# Access Compliance Report

## Public Rights-of-Way

Intersection ID: 26409	Main Street: KUYKENDALL_RD	Cross Street: PROVIDENCE_RD	Location: NE
ADA ID: 7C2E74A476F9	Ramp Type: PerpDiag	Initial Pass/Fail: Fail	Overall Compliance: No
		Severity Score: 8.75

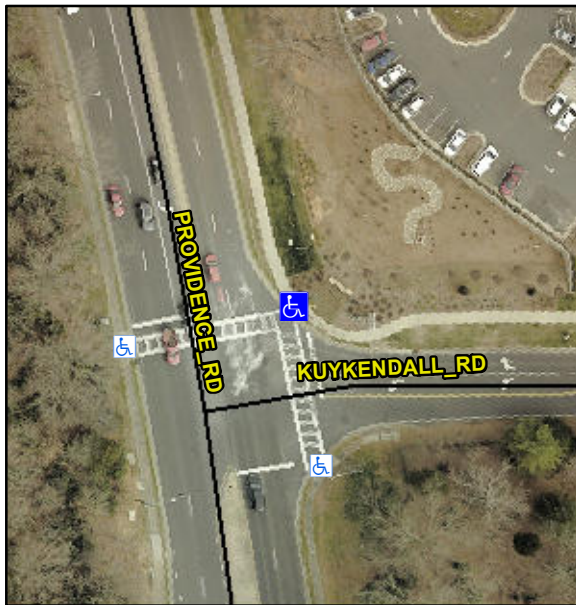
**Not Found, R304.5.1**

Compliance	Description	Data	Compliance	Description	Data
N/A	Ramp Length (in)	84.0	Yes	Ramp Slope (%)	7.6
No	Ramp Width (in)	47.0	Yes	Ramp XSlope (%)	1.6
N/A	Flare Type LT	N/A	N/A	Flare Type RT	N/A
N/A	Flare Slope LT (%)	N/A	N/A	Flare Slope RT (%)	N/A
N/A	Flare Traversable LT?	N/A	N/A	Flare Traversable RT?	N/A
N/A	Landing Length (in)	N/A	N/A	DWS Provided?	N/A
N/A	Landing Width (in)	N/A	N/A	DWS Contrast?	N/A
N/A	Landing Slope (%)	N/A	N/A	DWS Length (in)	N/A
N/A	Landing X Slope (%)	N/A	N/A	DWS Full Width?	N/A
N/A	Landing Curb? (Y/N)	N/A	N/A	DWS Offset (in)	N/A
N/A	Shared Landing?	N/A			
N/A	Gutter Ponding?	N/A	N/A	Gutter Slope (%)	N/A
N/A	Gutter Lip Ht (in)	N/A	N/A	Gutter X Slope (%)	N/A
N/A	Painted X Walk1?	Yes	N/A	Painted X Walk2?	Yes
	X Walk 1 Direction	To W		X Walk 2 Direction	To S
N/A	X Walk 1 Width (in)	75.0	N/A	X Walk 2 Width (in)	92.0
	X Walk 1 Slope (%)	4.3		X Walk 2 Slope (%)	1.9
	X Walk 1 X Slope (%)	2.2		X Walk 2 X Slope (%)	2.8

**Remove & Replace Curb Ramp With Two New Directional Ramps or Equivalent.**
